**HEARINGS EXAMINER MEETING AGENDA**  
**Thursday, October 18, 2018, 5:00 PM**  
**City Hall, 616 NE 4th Avenue**

Valley View Estates Subdivision Preliminary Plat Application Public Hearing (File No. SUB18-02)

Presenter: Lauren Hollenbeck, Senior Planner

Scale: AS SHOWN  
 Project Number: 286  
 Design/Drawn: JGS/BC  
 Drawing Date: JUNE 2018  
 Sheet 2 of 9 Sheet(s)

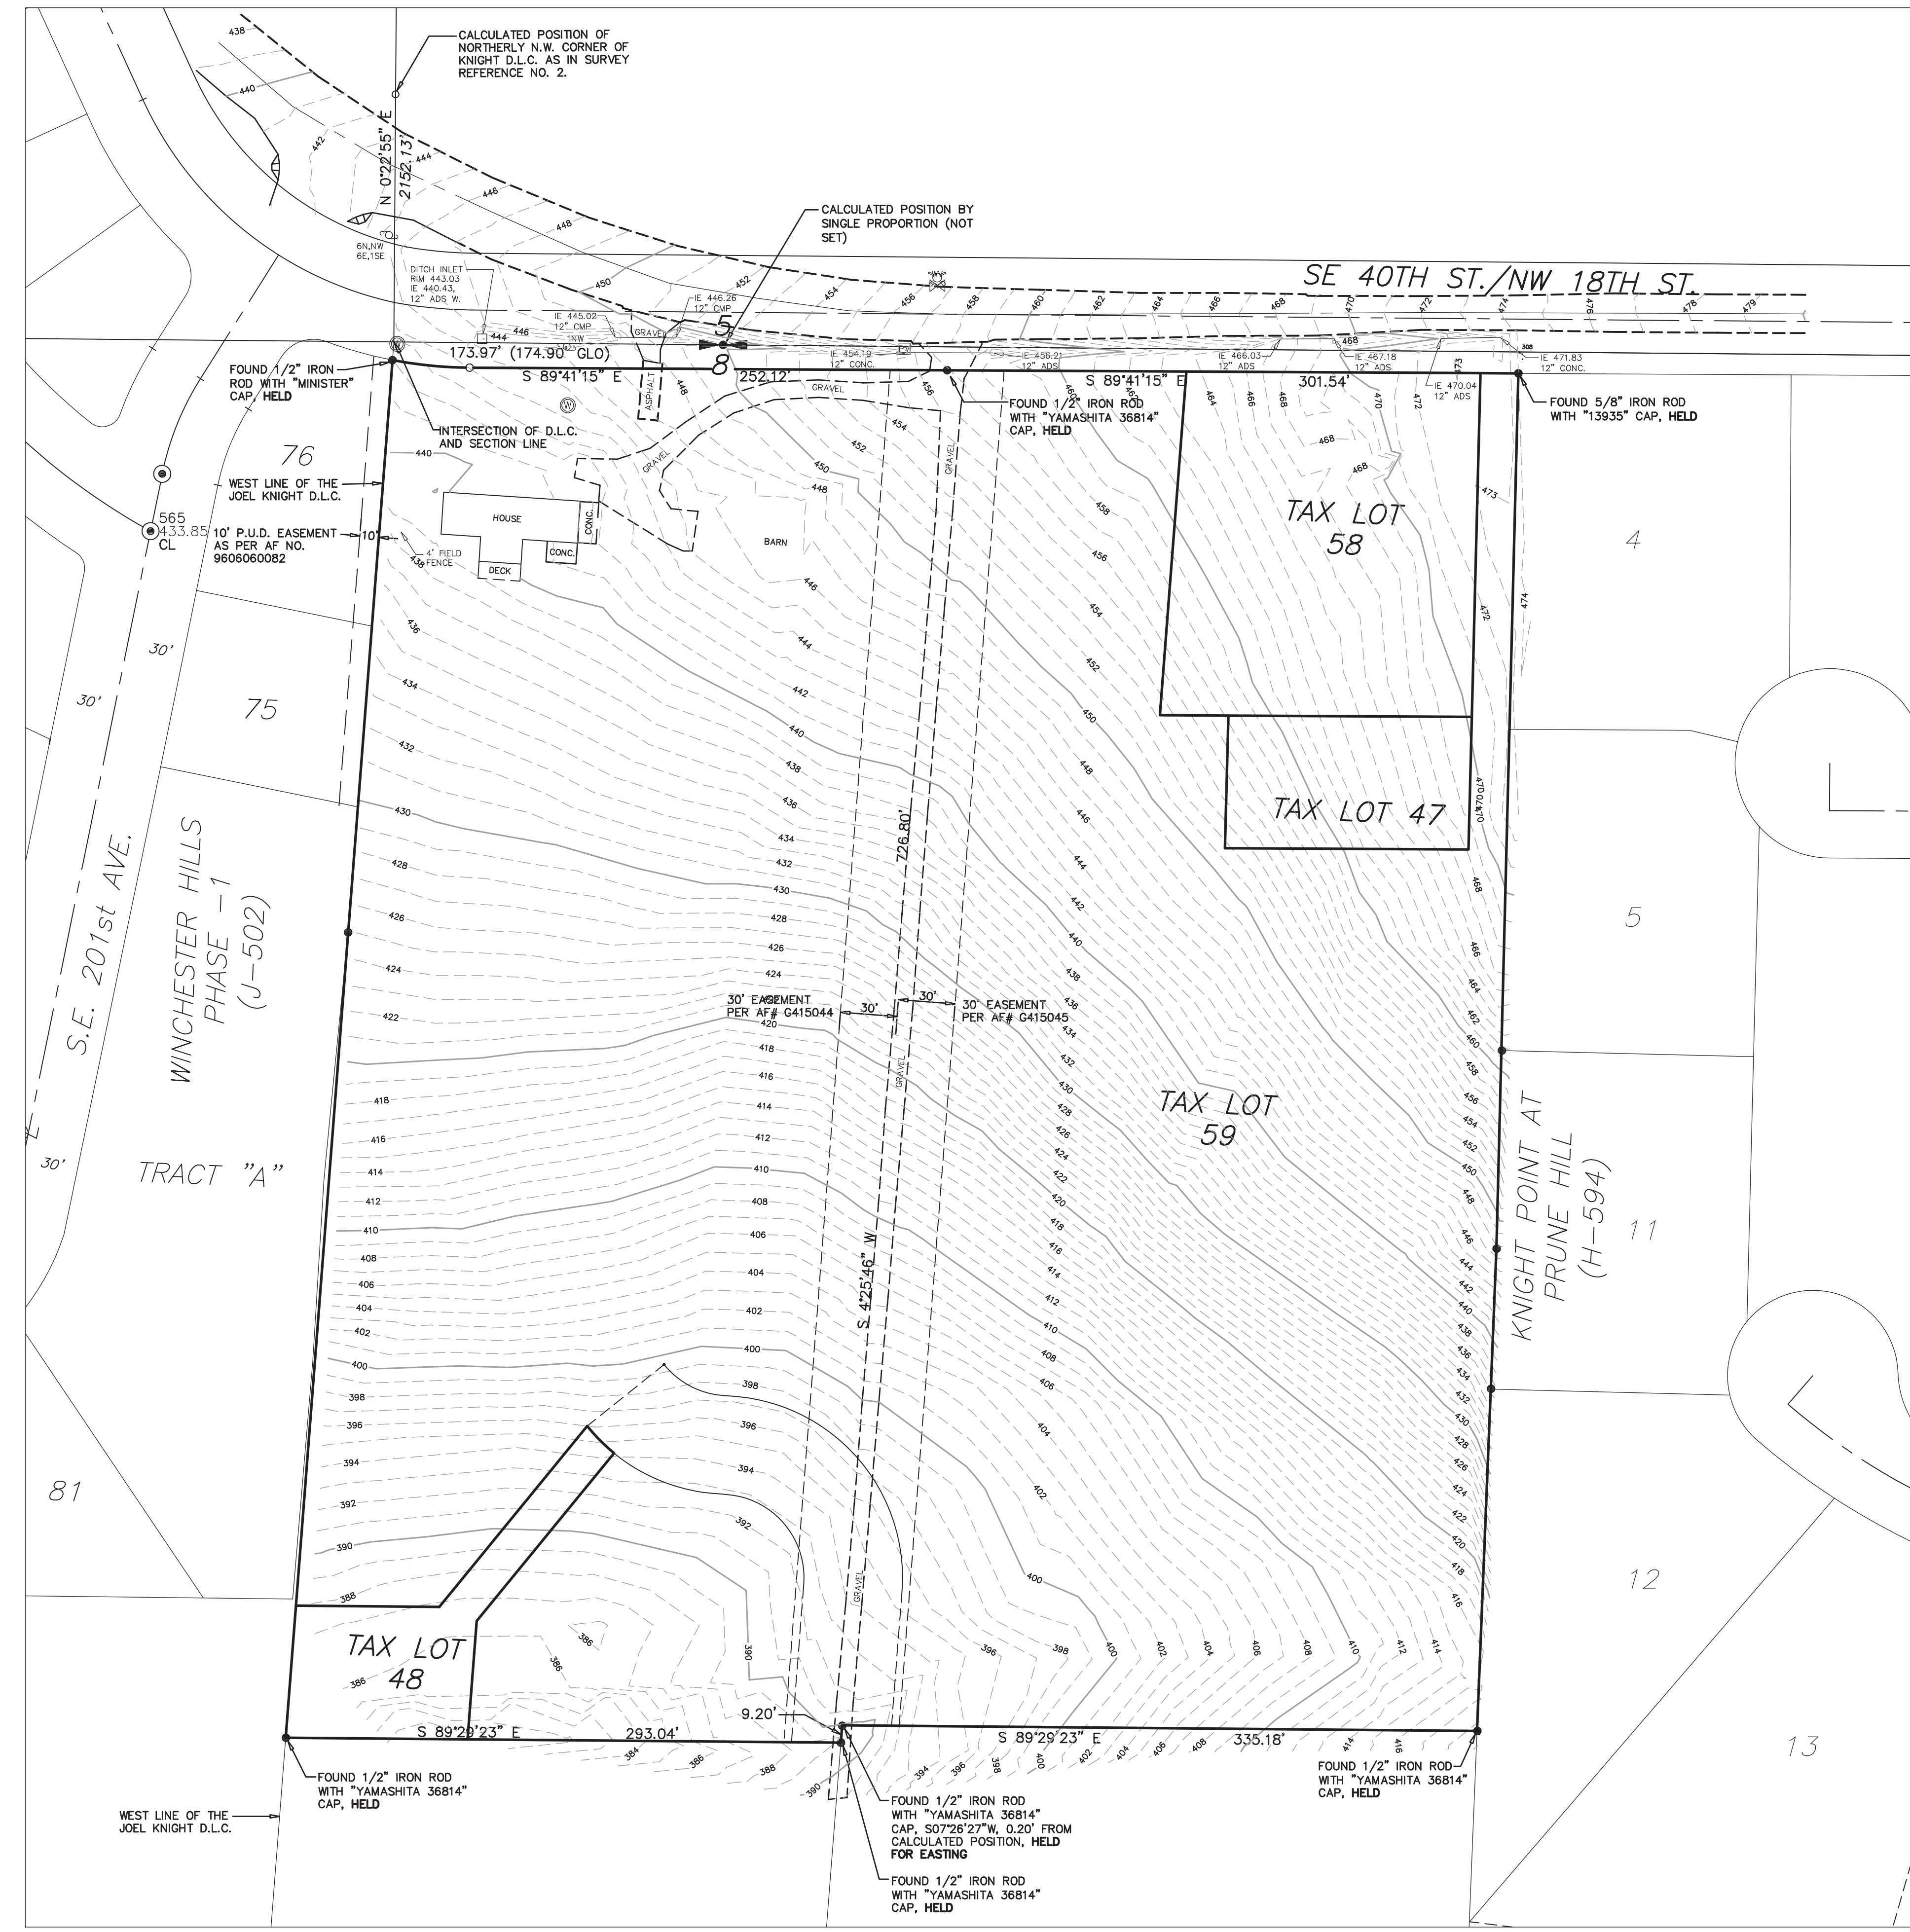
4. Lot 30 building envelope may be extended per the 5-foot corner lot rear yard setback requirement pursuant to CMC 18.09.040.
5. Land inventory should be corrected on sheet 2 of 9. Site area and developed acreage should be the same. The infrastructure acreage should only include the stormwater tracts.

6. The setbacks table should also include "corner lot rear yard" on sheet 2 of 9.
7. Lots 1, 19, 23, 24, 26, 27 and 32: Walls in front yards cannot exceed 42-inches in height per CMC 18.17.050.C.2.
